APPLICANT(S) Joseph Louis Petrucci, Jr. **GROUP ART**
UNIT:Unknown
APPLN. NO.: EXAMINER: Unknown
FILED: Concurrently Herewith
TITLE: METHOD AND SYSTEM FOR DETERMINING A
PERFORMANCE OF PLASMA ETCH EQUIPMENT

PRELIMINARY AMENDMENT

FIG. 1

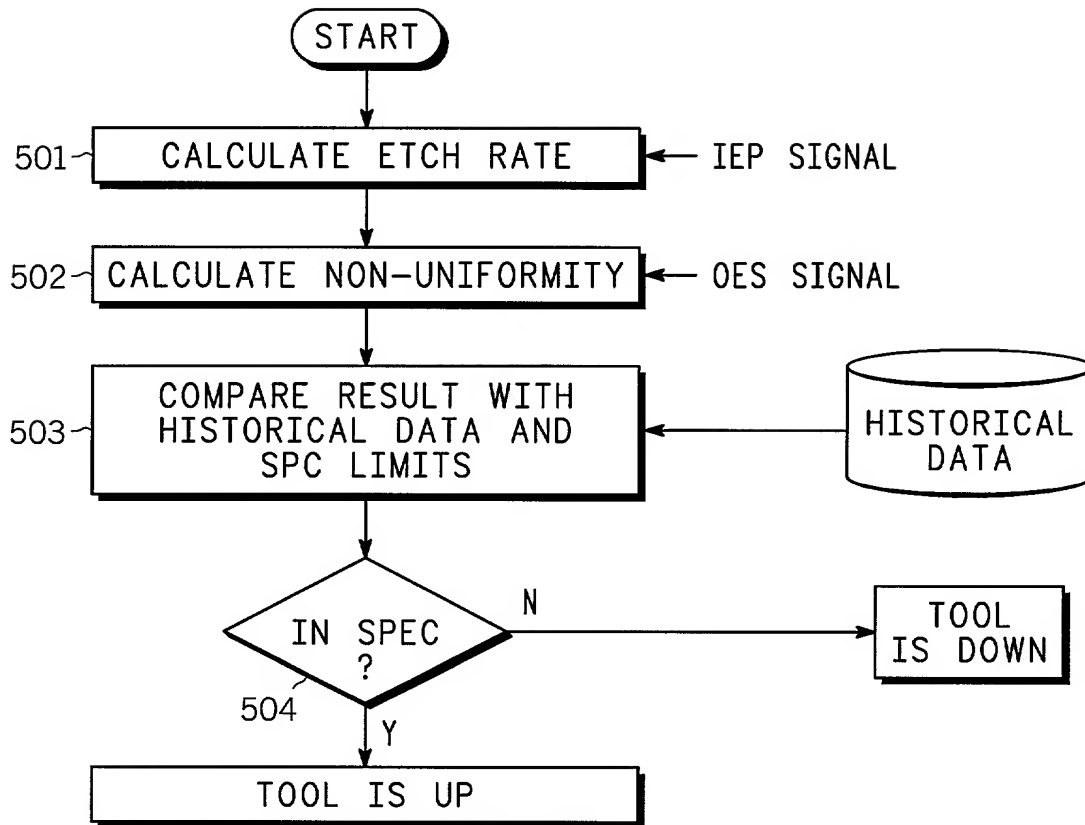
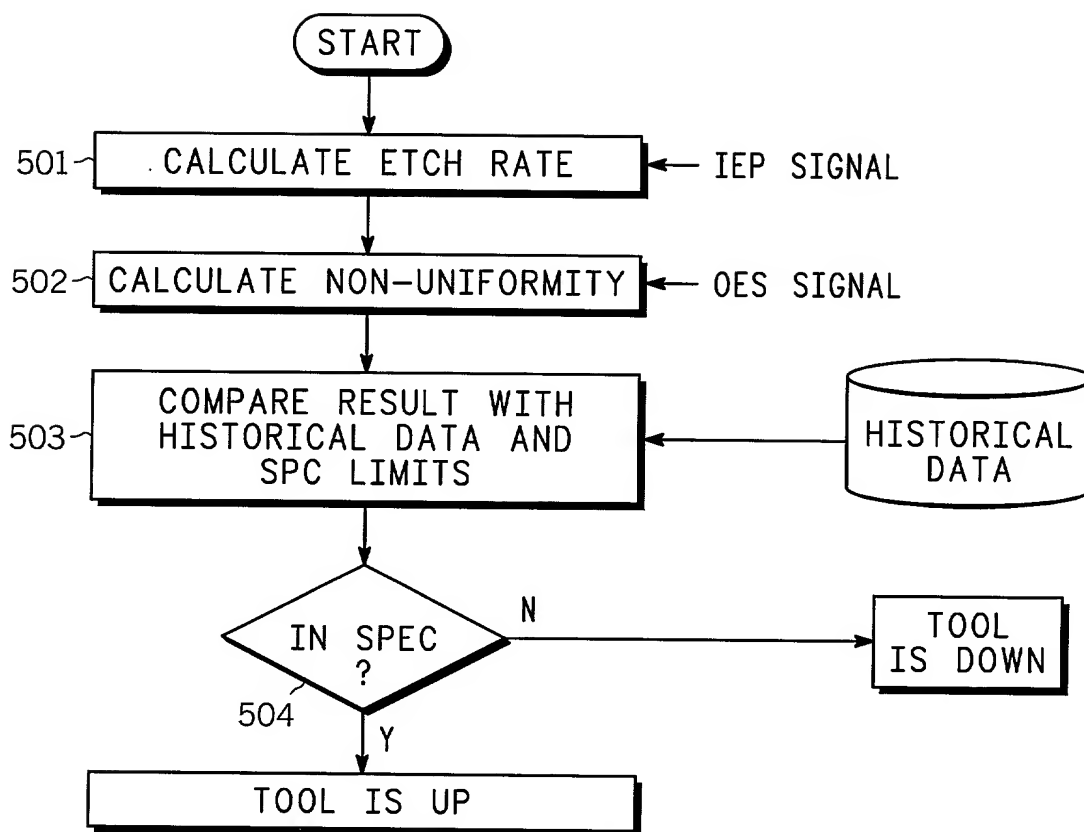
The amendments to the specification are made so that the specification is consistent with FIG. 1. The amendment to FIG. 2 is made to correct a typographical error in the label of block 14.

After starting the process, in step [S01] 501 an etch rate is calculated. The etch rate is calculated, for example, by analyzing an IEP signal which will be described further below with reference to Figure 3. The etch rate can also be calculated on the basis of an OES signal. Such analysis will be described further below with reference to Figure 4.

After calculating the etch rate, in step [S02] 502 the non-uniformity of a film to be etched is calculated. The calculation of the non-uniformity is performed on the basis of an OES signal which will be described with reference to Figure 4 further below.

After calculating the non-uniformity, in step [S03] 503 the results of etch rate calculation and non-uniformity calculation are compared with historical data and/or statistical process control (SPC) limits.

In step [S04] 504 it is decided, whether the calculated etch rate and the calculated non-uniformity are within a specification, on the basis of the step of comparing ([S03] 503). If the results are within the specification it is decided that the plasma etch tool is up, and normally no measures have to be taken. If both or one of the calculated values is not in the specification, it is decided that the tool is down. In this case, for example, the tool can be removed from the production line.

FIG. 2

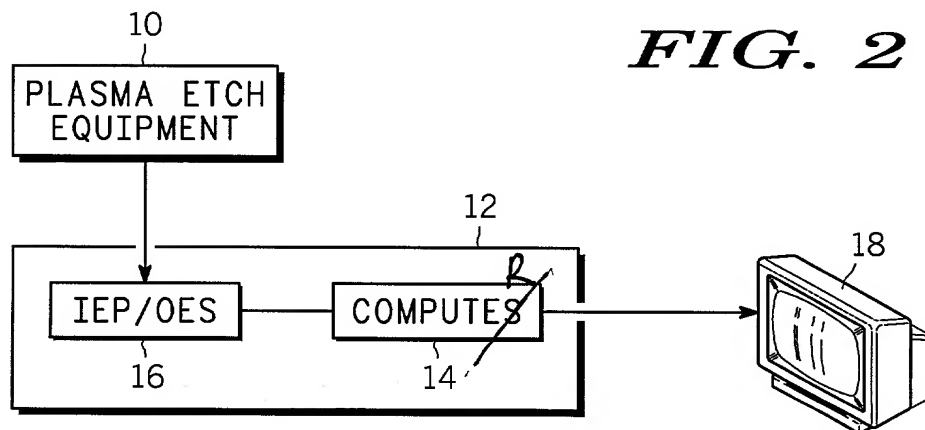
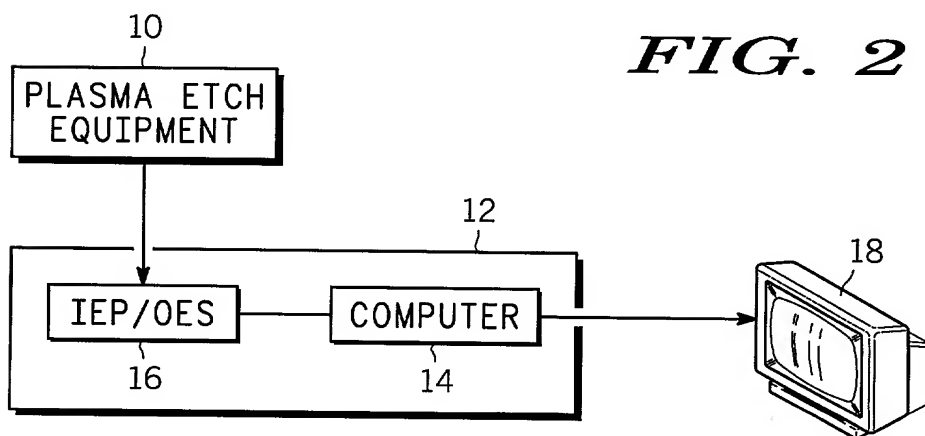
In FIG. 2 of the drawings, block 14 original read "COMPUTES", but is corrected to read - -COMPUTER- -as noted on the red-lined drawing of sheet 1/2.
